DPR 25-18: Walmart Market Avon Avenue

Planning & Building Department Staff Report

For Hearing on March 23, 2026

A. PETITION NUMBER	DPR 25-18: Walmart Market Avon Avenue
B. APPLICANT	Walmart Real Estate Business Trust, c/o Michael Rabinowitch
C. LOCATION	1439 South Avon Avenue, Avon IN 46123 Lot 2 in Governors Row Road Extension at Turner Trace

Exhibit B2 – Revised Site Plan (11-March-2026)

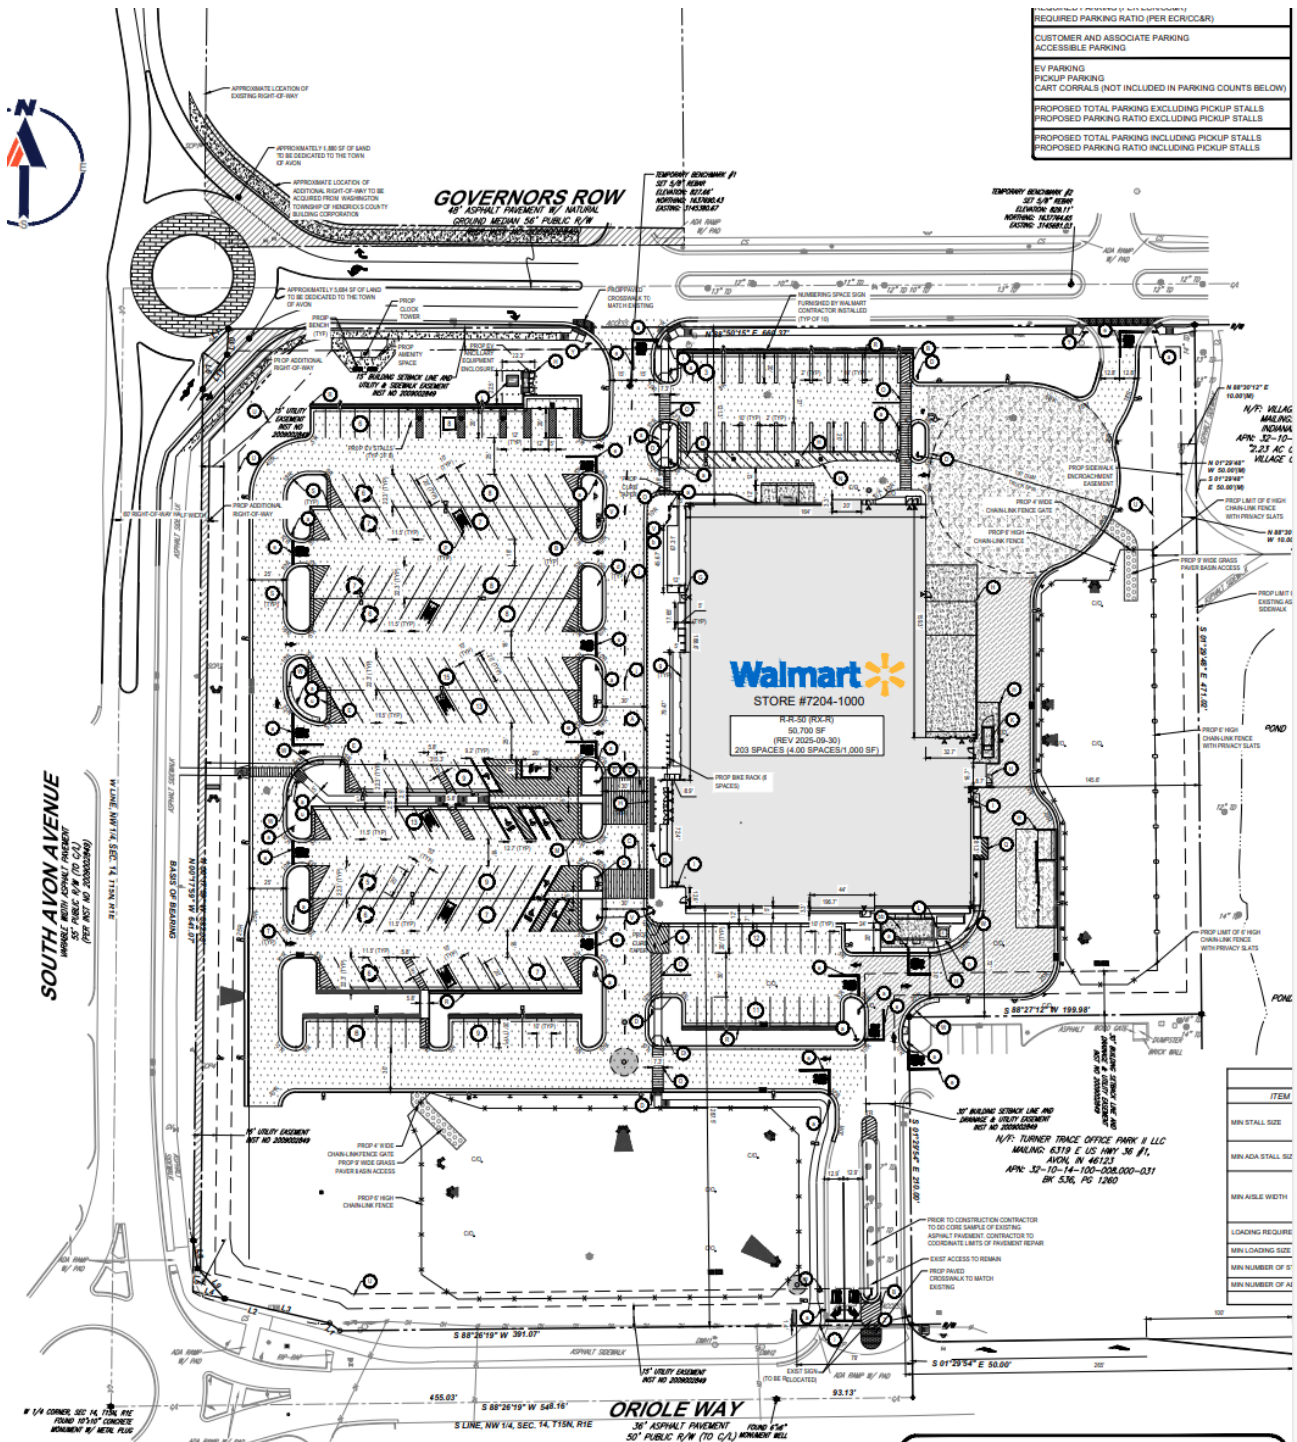
Revised site and landscape plans were submitted February 12, 2026 (see Exhibits B2 & C3) that address the issues raised by staff regarding bicycle racks, foundation plantings, interior parking lot landscaping, and the required site amenities. Additionally, more information was provided with the architectural plans to verify compliance with the glazing and roof requirements.

The revised site plan indicates a triangular median at the proposed Avon Avenue access point, which would be intended to prevent left turns to/from the site. A revised version of the petitioner's Traffic Impact Study (TIS) was submitted on February 9, 2026, which added a third scenario examining the proposed Avon Avenue access point as right-in, right-out only. Staff has consulted with the Department of Public Works and the Town's consulting engineer for review of the revised study.

c) **Bicycle Parking:** The UDO requires one bicycle rack per every twenty (20) required vehicle parking spaces, thus, six (6) bicycle racks would be required. While the revised site plan shows bicycle racks in a compliant location, the plan only indicates five racks. At least one additional rack would be required.

Exhibit C2 – Areas Deficient of Foundation Planting Requirement

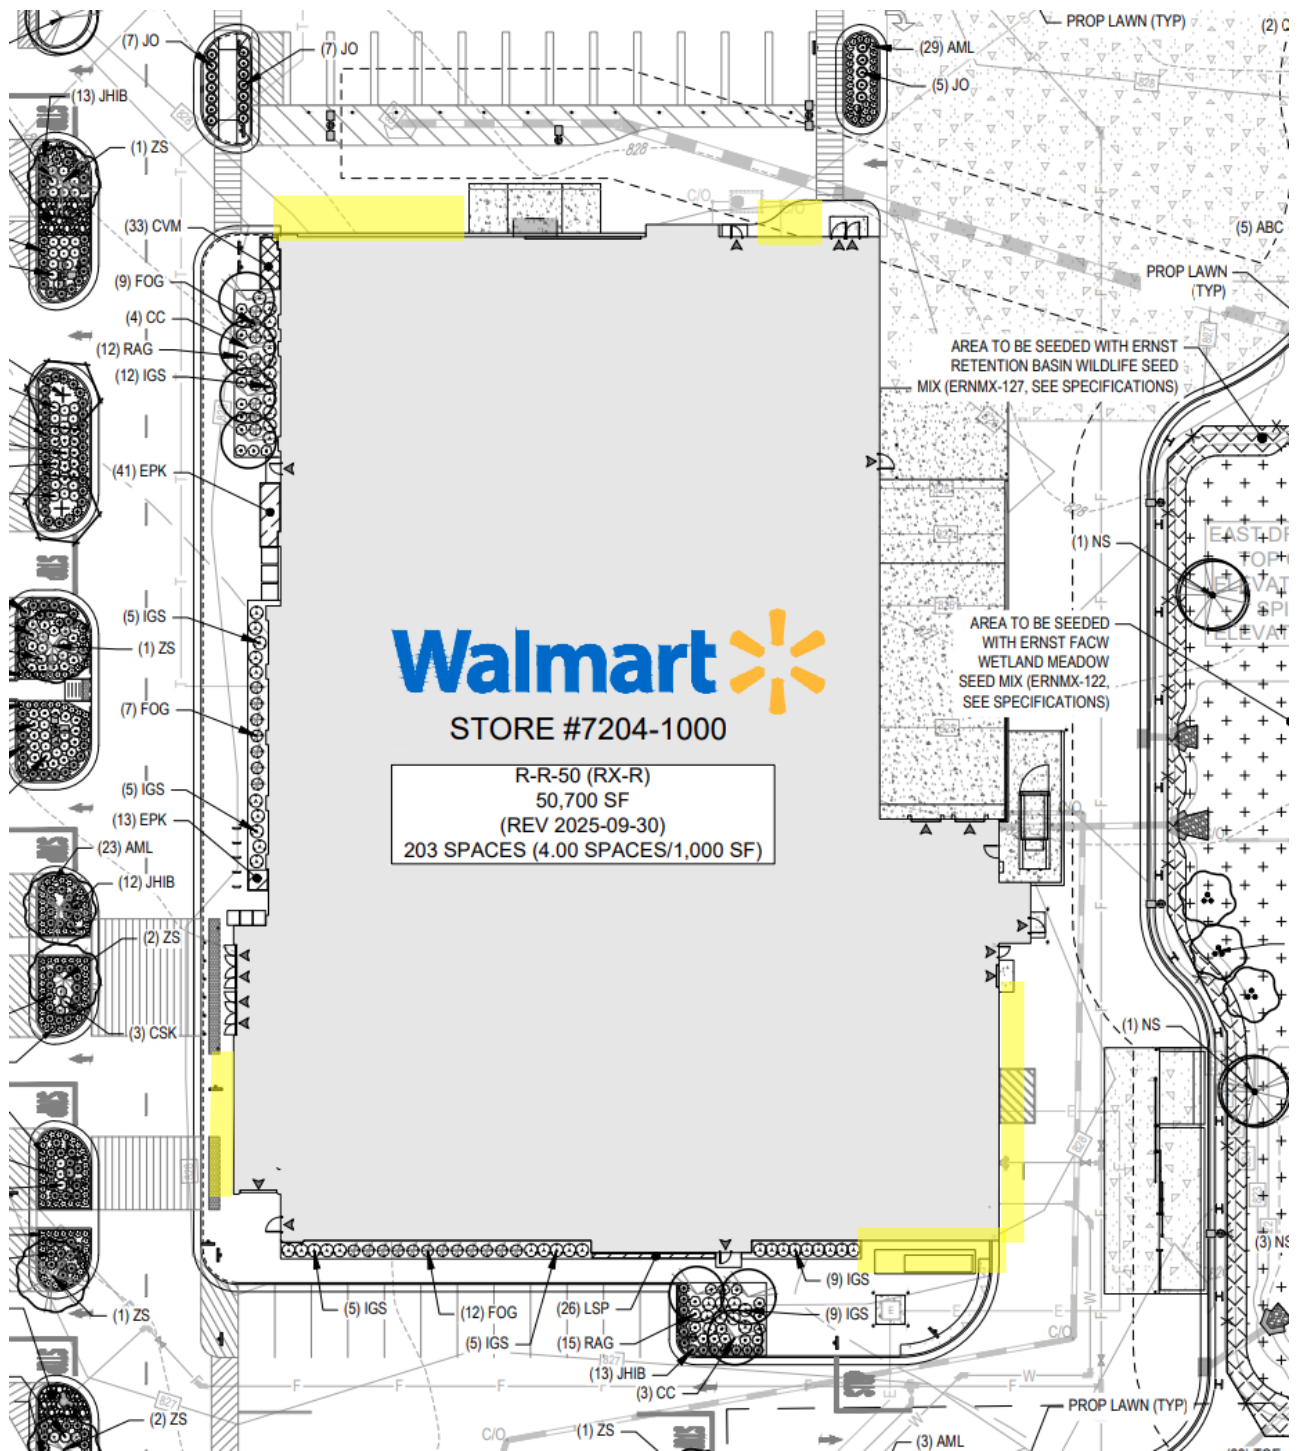
Per UDO 6.5 (A), a minimum five-foot planting area must be provided around the perimeter of the building, excluding access to the buildings, such as loading areas and doorways. The landscape plan submitted subsequent to TAC review has increased the proposed foundation planting areas, but is still deficient along several portions of the building (see Exhibits C1 & C2).

A further revised landscape plan should be submitted to demonstrate compliance with the foundation planting and interior parking lot landscaping requirements.

Exhibit E – Aerial Photo w/ Measurements of Proposed Driveway Separation

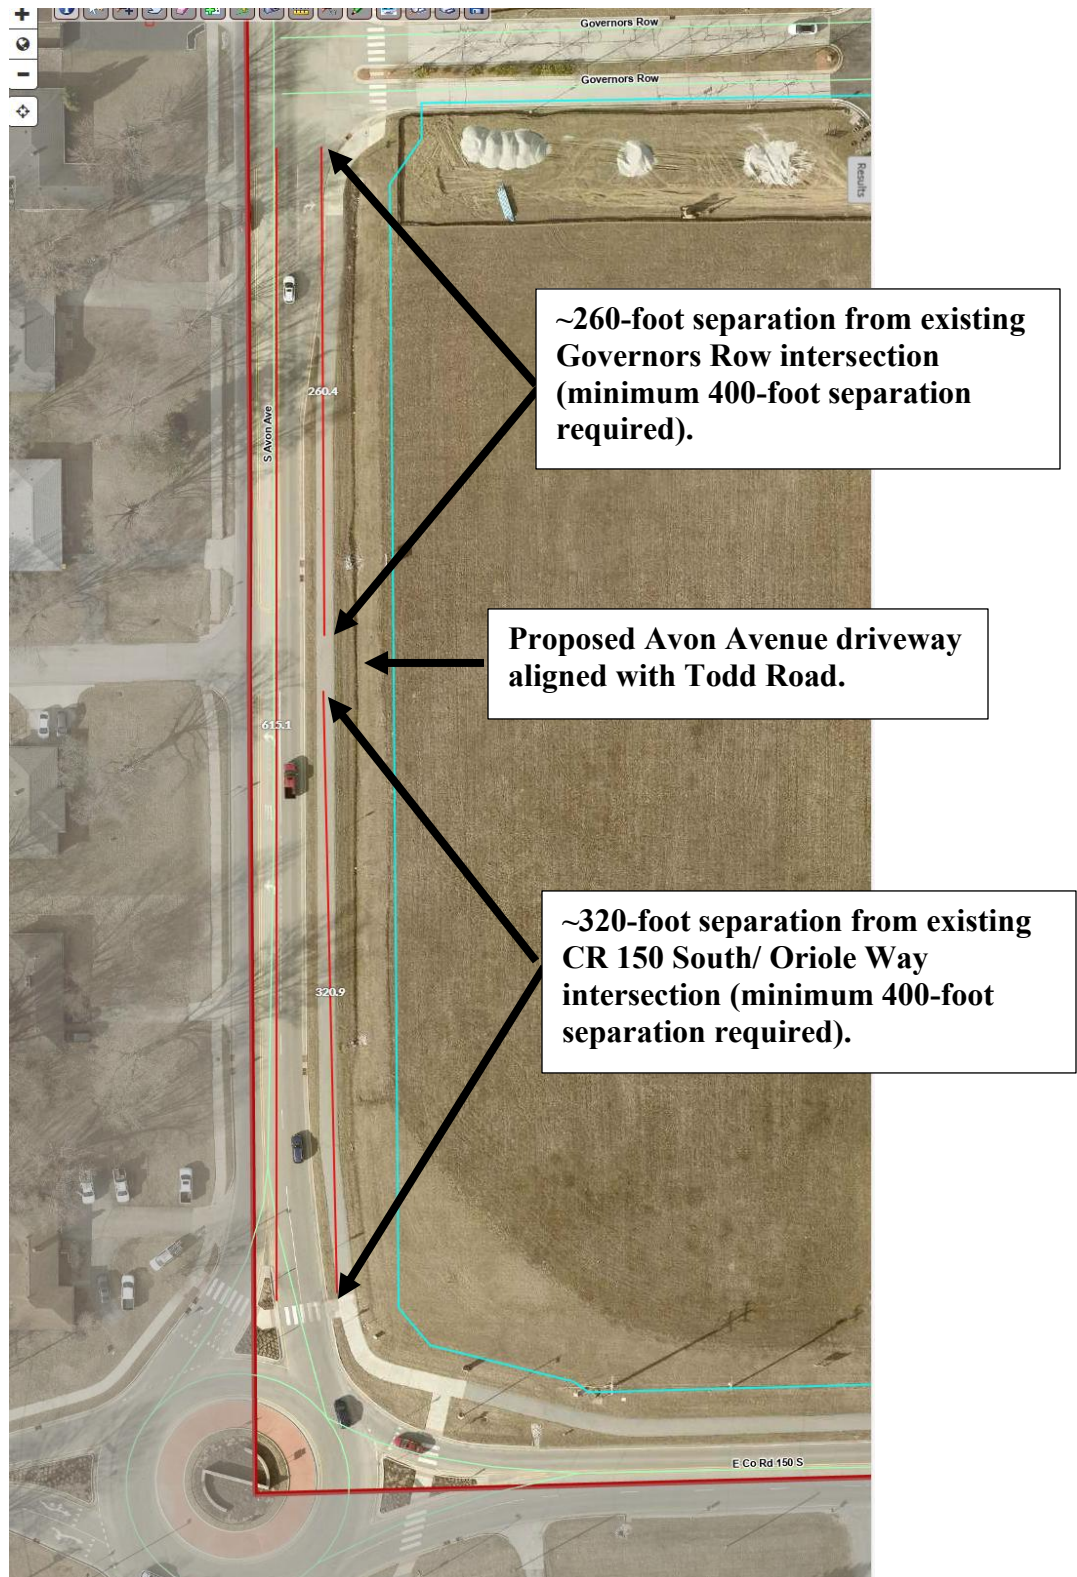
Waiver of Design Standards of UDO 7.21(E)(1), to allow for a new full-access commercial driveway onto Avon Avenue being ~260 feet from Governors Row and ~320 feet from County Road 150 South/ Oriole Way (minimum 400-foot separation from each existing intersection required).

It is the opinion of the Town's Public Works Director and consulting traffic engineer that inadequate spacing of intersections along an arterial street with a 45 MPH speed limit would increase the risk of collisions and injuries. Staff believes this finding would not be met.

The Town's consulting traffic engineer indicates that, in addition to not meeting the Town's minimum standard, the proposed alternative would also be deficient of the 360-foot separation standard for a 45 MPH roadway that is indicated in INDOT's Driveway Permit Manual. Staff believes this proposal does contradict the intent of the Town's public street and access design standards.

While the property's frontage is not lengthy enough to meet the separation standards for a new direct access point to Avon Avenue, the site is already served by driveways onto County Road 150 South/ Oriole Way and onto Governors Row, both of which provide full access to/from Avon Avenue.

Staff recommends denial of this waiver request.

Exhibit F – Lighting Plan

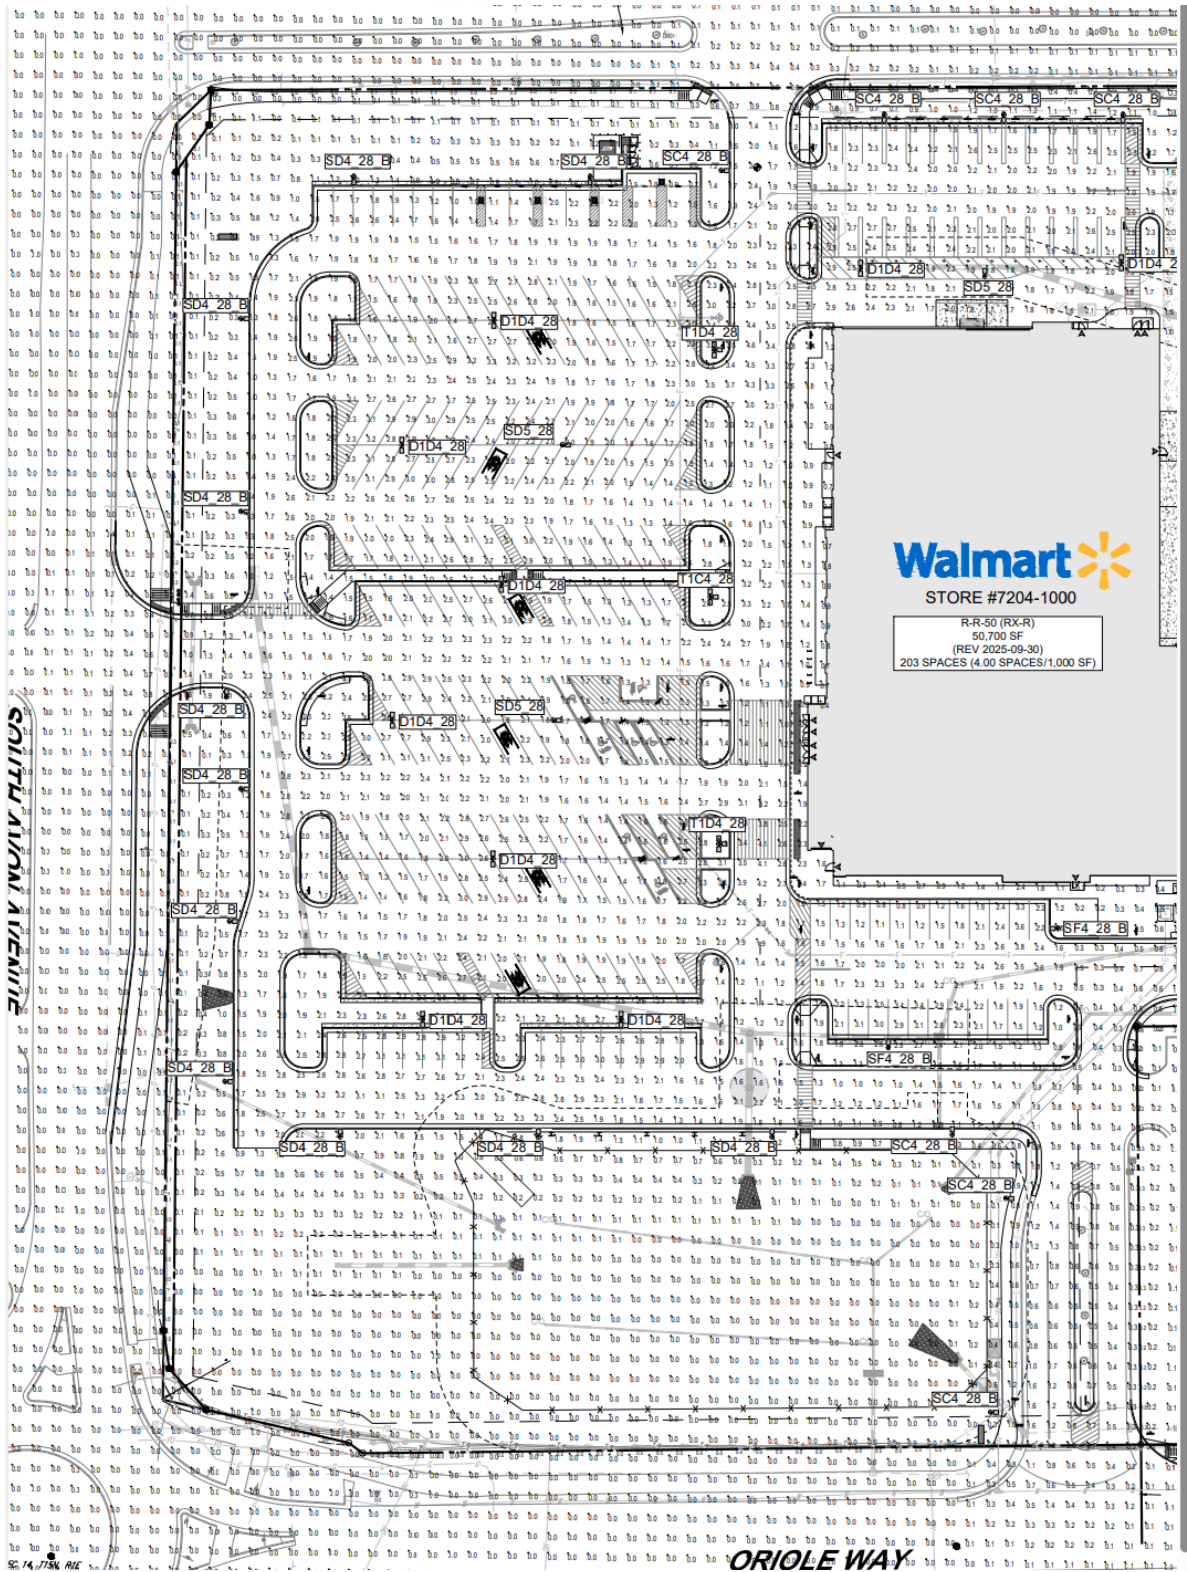
Two waivers of development standards have been requested to allow for excessive parking lot lighting and excessive light spillage into rights-of-way (see Exhibit F), which is discussed later in this report.

Waiver of Development Standards of UDO 6.10(A), to allow light spillage of 0.4 foot-candles (Fc) into the abutting rights-of-way, which exceeds the 0.3 Fc maximum allowed.

Staff concurs with the petitioner’s assertion that this is a minor deviation, and the Town is generally not opposed to slightly higher light spillage at an intersection (see Exhibit F).
